### **WALSH BAY ARTS AND CULTURAL PRECINCT**

RESPONSE TO SUBMISSIONS
SSDA 8671

APPENDIX 7:
TZG RESPONSE TO HERITAGE COUNCIL SUBMISSION

Figure 5: Wharf 4/5 eastern signage

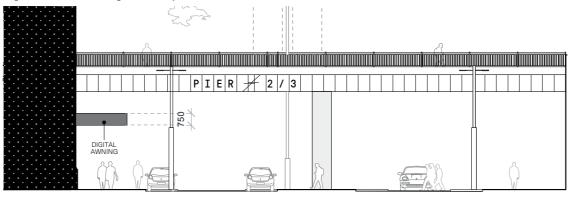
The detailed design of building identification and wayfinding signage must be visually consistent and specifically designed to respect the integrity of the industrial character of the Precinct.

A Signage and Wayfinding Strategy, prepared by Urban & Public, accompanies the proposal. It advocates signage that is consistent in design, is of a high standard of materials, construction and graphics and is appropriately located. The building identification and wayfinding signage will be visually consistent and respect the integrity of the industrial character of the Walsh Bay Wharf precinct.

An overview of the signage and wayfinding concepts approval is sought for is included in the revised Signage Plan overleaf, which rationalises the number of tenant identification signs within the Walsh Bay Arts and Cultural Precinct. The signs have been sized to relate to the original fabric of the wharves, and are hence different for Pier 2/3 and Wharf 4/5. The proposed signs are indicated in the perspectives to the right, shown in red for clarity, with the proposed digital walls marked orange.
